# UNITED STATES PATENT AND TRADEMARK OFFICE

<b>Office Action Summary</b>	<b>Application No.</b>	<b>Applicant(s)</b>
	10/619,688	STREIFF ET AL.
	<b>Examiner</b>	<b>Art Unit</b>
	Charles E. Cooley	1723

## **FINAL OFFICE ACTION (AFTER RCE)**

FIG. 1

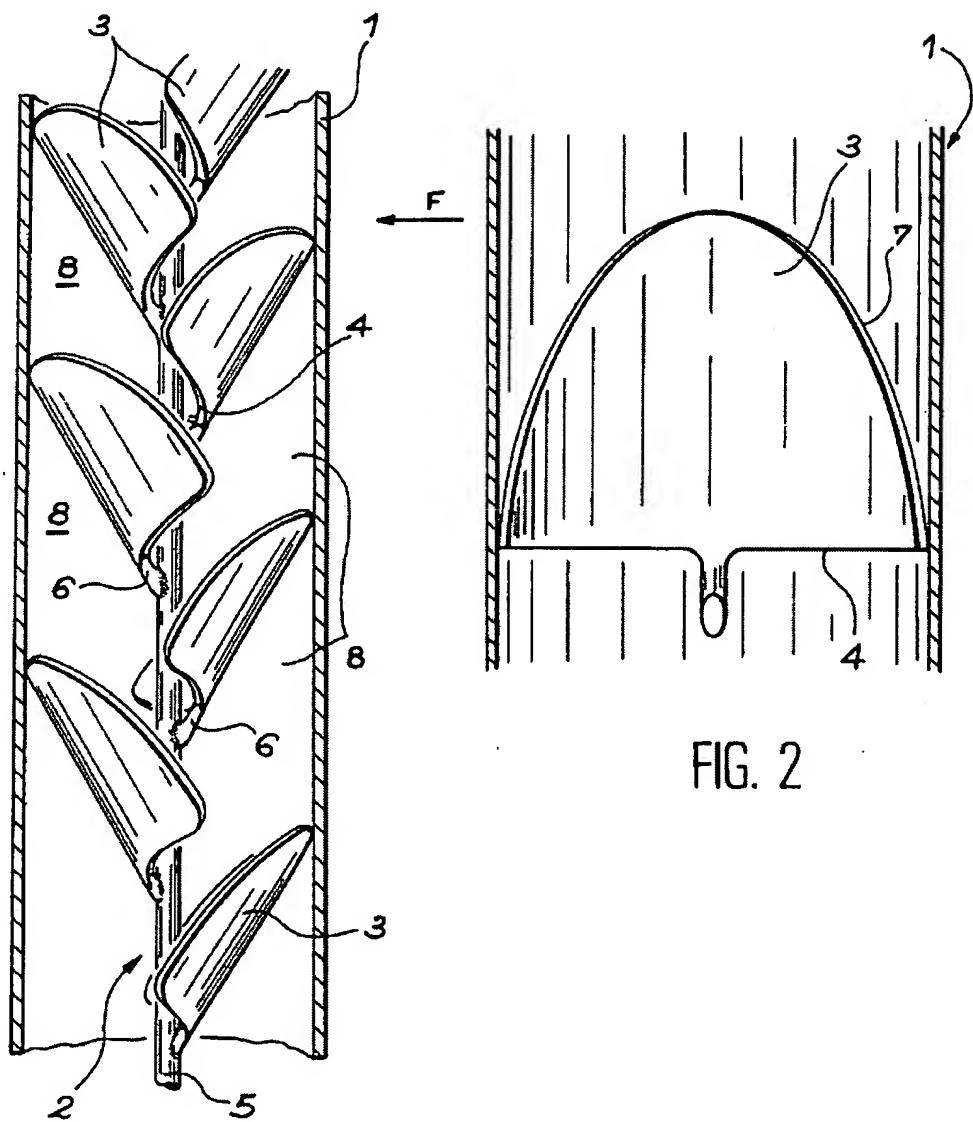
WO 98/47791 discloses a static mixer as seen below comprising a static mixer assembly (Fig. 1) with a generally ring-shaped fluid flow conduit 1 having a central axis (along 5), concentric inner and outer, radially spaced, circumferentially extending surfaces, said inner surface defining a fluid flow path which extends along said axis; one or more static mixers 2 located in said flow path, each static mixer having a plurality of spaced crossing elements forming one or more first grids (the elements 3 on the left side of the conduit 1 in Figure 1) and one or more slots 8 positioned between and

adjacent to each crossing element 3 of the one or more first grids; a second plurality of spaced crossing elements forming one or more second grids (the elements 3 on the right side of the conduit 1 in Figure 1) and one or more slots 8 positioned between and adjacent to each crossing element 3 of the second grids; wherein said crossing elements 3 of said first grid(s) are arranged at intersecting angles to said crossing elements 3 of said second grid(s), and wherein said grids are arranged such that each crossing element 3 of one grid intersects and extends at least partially through a slot 8 in the other grid (i.e., note the crossing elements 3 of the first and second grids at least partially circumferentially overlap such that portions of the crossing elements extend into slots of the opposing grid(s) as seen in Figure 1); at least one elongated connector 5 positioned between and secured to said crossing elements 3 of said first grid(s) and said crossing elements of said second grid(s); wherein said crossing elements 3 of said first grid(s) are in a generally parallel relationship relative to one another (Fig. 1); wherein said crossing elements 3 of said first grid(s) lie within a common plane (the plane to the left of the axis defined by connector 5); wherein said crossing elements 3 of said second grid(s) are in generally parallel relationship relative to one another (Fig. 1); wherein said crossing elements of said second grid(s) lie within a common plane (the plane to the right of the axis defined by connector 5); wherein said crossing elements are corrugated plates (a groove on the concave side parallel to the peak on the convex side); wherein the static mixer comprises more than two grids with each grid comprising crossing elements 3 (note Fig. 1 is a broken view depicting a plurality of crossing elements spaced along the axis of the conduit and since but two crossing elements on

each of the opposite sides of the connector can constitute a grid, a multitude of grids are spaced along the length of the conduit); wherein said connector 5 extends continuously along the entire cross-sectional length of said static mixer (Fig. 1); wherein said elongated connector 5 is positioned so that it intersects with said crossing elements along at least some of their points of intersection (Fig. 1). Although the product-by-process subject matter of claim 41 is not germane to the patentability of the product, note the crossing elements 3 are apparently secured to said connector 5 by welding (proximate 6 in Fig. 1).

WO 98/47791 also discloses a method of constructing a static mixer, in light of the explanations above, comprising providing at least two grids; positioning at least two spaced crossing elements 3 and one or more slots 8 between and adjacent to each crossing element 3 in a first grid; positioning at least two spaced crossing elements 3 and one or more slots 8 between and adjacent to each crossing element in a second grid; arranging said crossing elements 3 of said first grid at intersecting angles to said crossing elements 3 of said second grid; arranging said grids such that each crossing element of one grid intersects and extends at least partially through a slot 8 in the other grid; positioning at least one connector 5 between said crossing elements 3 of said first grid and said crossing elements 3 of said second grid; and securing said connector 5 to said crossing elements 3; providing more than two grids along the length of the conduit 1; and positioning one or more crossing elements 3 in each grid.

WO 98/47791 discloses that the connector 5 is positioned between said crossing elements 3 of each grid as seen in Figure 1 but does not disclose the crossing elements of each grid being arranged at intersecting angles to one another. The patent to Katzen '618 discloses in Fig. 5 a static mixer comprising spaced grids of crossing elements 29 that are secured to a central connector 28. The crossing elements 29 of adjacent grids are arranged at intersecting angles to one another as seen in Fig. 5. It would have been obvious to one having ordinary skill in the art, at the time applicant's invention was made, to have modified the arrangement of the grids in WO 98/47791 such that crossing elements of each grid are arranged at intersecting angles to one another as disclosed by Katzen '618 for the purpose of providing a highly effective sheer action on the fluid and providing a swirl action (col. 4, line 43 through col. 5, line 3).

WO 98/47791 does not discloses the recited materials of the crossing elements but apparently shows the crossing elements 3 secured to the connector 5 by welding (proximate 6 in Figure 1). Assuming this is not the case, the patent to Horner '188 discloses a static mixer 20 and a method of constructing said static mixer comprising providing a first grid 32 comprising one or more crossing elements 38 and one or more slots adjacent to each crossing element 38 (Fig. 2 and col. 4, lines 60-63) and providing a second grid 34 comprising one or more crossing elements 38' and one or more slots adjacent to each crossing element 38' (Fig. 2 and col. 4, lines 60-63) wherein said crossing elements 38 of said first grid 32 are arranged at intersecting angles to said crossing elements of said second grid (Fig. 2 and col. 4, lines 19-23); and positioning at least one elongated connector 36 positioned between and secured to said crossing elements 38 of said first grid and said crossing elements 38' of said second grid; said grids 32, 34 are arranged such that each crossing element of one grid intersects a slot in the other grid (Fig. 2); said crossing elements 38 of said first grid 32 are in a generally parallel relationship relative to one another (col. 3, lines 60-64); said crossing elements 38 of said first grid 32 lie within a common plane (Figs. 2 and 4); said crossing elements 38' of said second grid 34 are in generally parallel relationship relative to one another (col. 3, line 67 through col. 4, line 3); said crossing elements 38 of said second grid lie 34 within a common plane (Figs. 2 and 4); said crossing elements are one of corrugated plates and tubes (col. 5, lines 37-48); the static mixer 20 comprises more than two grids
